**TITLE:** **SPECIAL PERMIT NO. 1992, EDENTON WOODS COMMUNITY UNIT PLAN**, requested by Engineering Design Consultants on behalf of Caseyco, for 46 single-family and attached single-family units, with a request to waive the minimum lot area, on property generally located northeast of the intersection of Ashbrook Drive and Highway 2 (adjacent to the west of the former Pine Lake S.I.D.).

## LINCOLN CITY/LANCASTER COUNTY PLANNING STAFF REPORT

**ANNEXATION NO. 03004;  
CHANGE OF ZONE NO. 3387;  
SPECIAL PERMIT NO. 1992, EDENTON WOODS  
COMMUNITY UNIT PLAN;  
and  
PRELIMINARY PLAT NO. 02023, EDENTON WOODS**

**To:** Brian Will, Planning Department  
**From:** Chad Blahak, Public Works and Utilities  
**Subject:** Edenton Woods Preliminary Plat and Special Permit  
**Date:** 6/27/03  
**cc:** Randy Hoskins

EDENTON WOODS  
Preliminary Plat  
Sheet 1 of 4

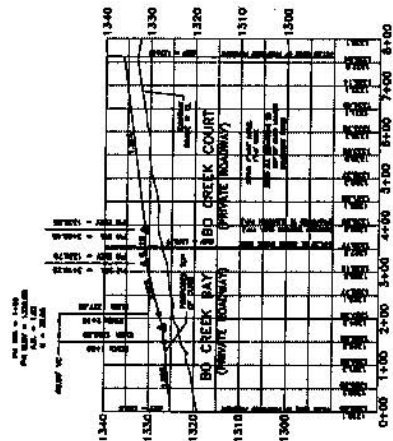
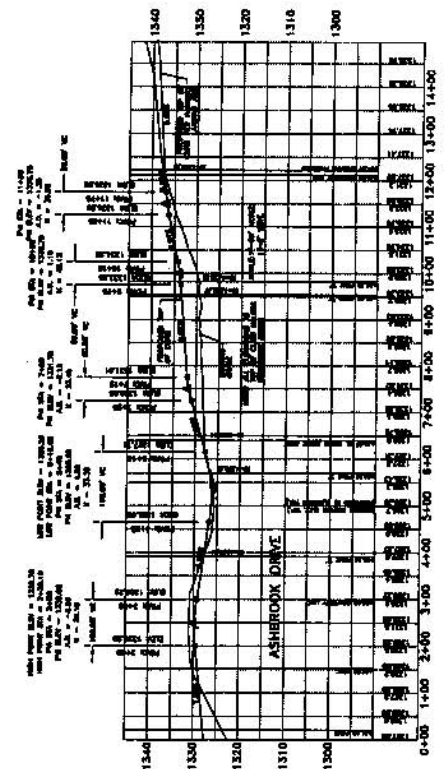
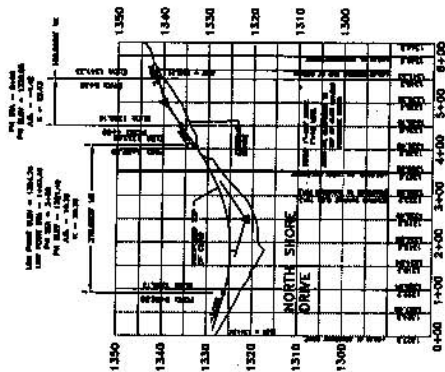
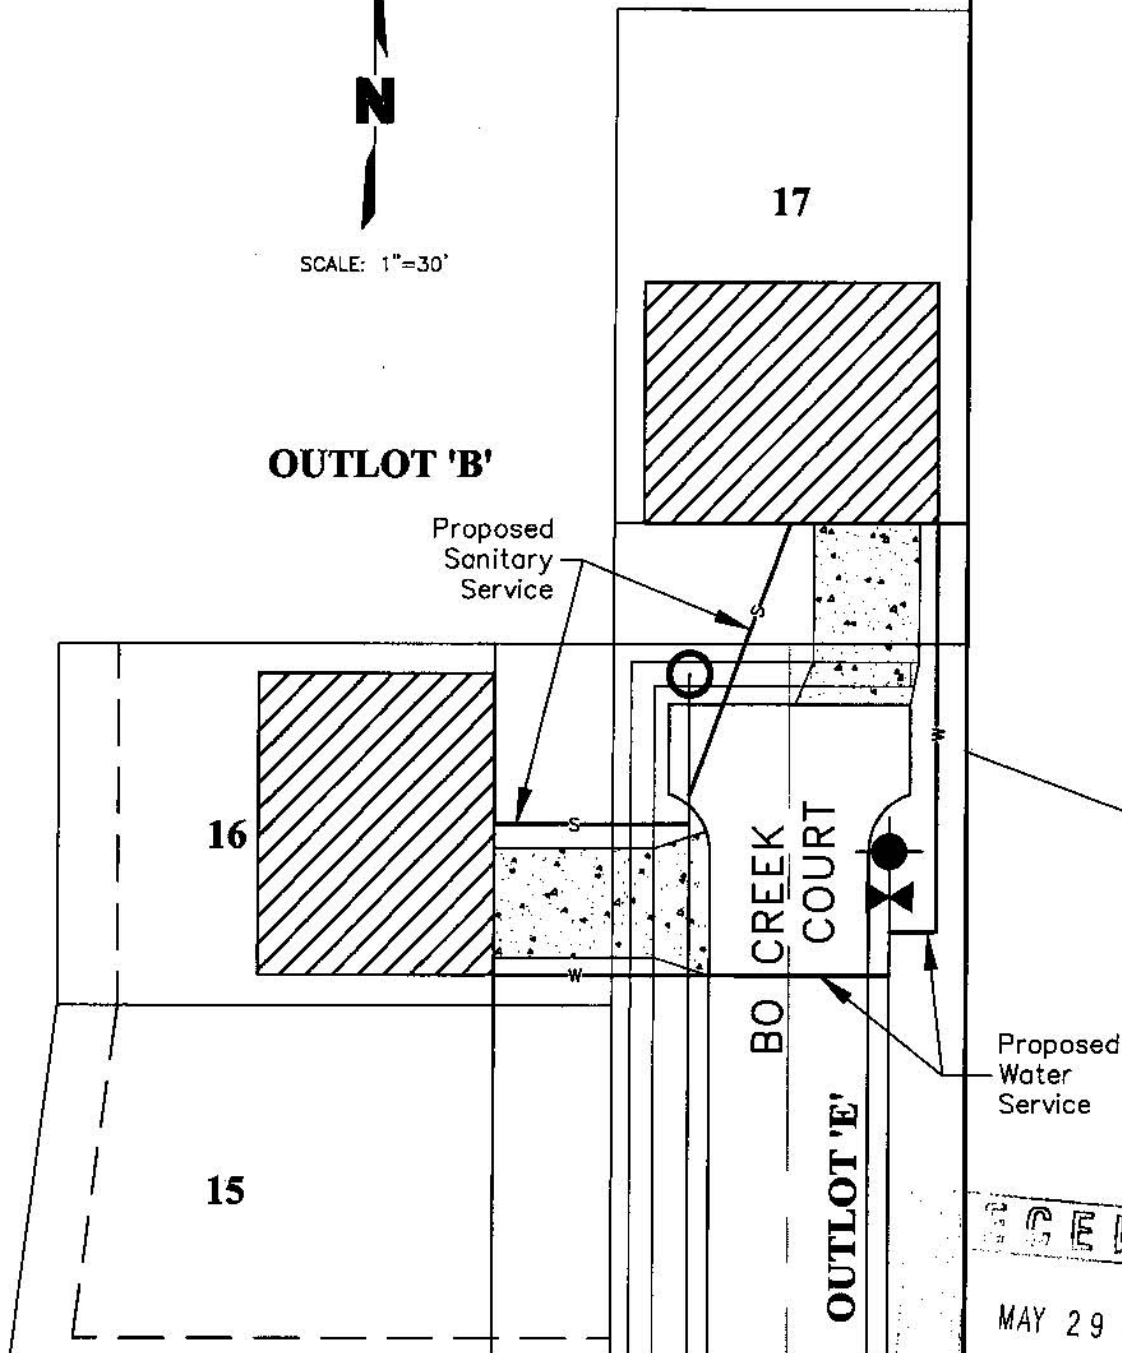
- The turnarounds in Bo Creek Court and Bo Creek Bay do not meet subdivision requirements. It appears that 30' radius turnarounds would fit at both ends. The plans should be revised to show 30' radius turnarounds. A barricaded dead-end for a permanent turnaround is unsatisfactory.

- According to the culvert calculations shown on the plans, the 50yr and the 100yr storms will flood the lots north of North Shore Drive. Also, the water elevation at the outlet of the culvert shown indicates that lots south of North Shore Drive along the channel will also be flooded. Public Works recommends that the lots be raised or reduced in depth to eliminate the flooding of any lot for any storm less than or equal to the 100yr storm.

- The minimum opening elevations shown for Lots 2 & 3 Block 3 are well below the grades shown for the swale that is shown on the property line. Revisions to the grades or the minimum elevations need to be made to address this issue.

- The areas designated as tree removal do not match the proposed grading contours. It appears more trees will need to be removed according to the contours. The contours need to be revised or the tree removal hatch needs to be adjusted accordingly.
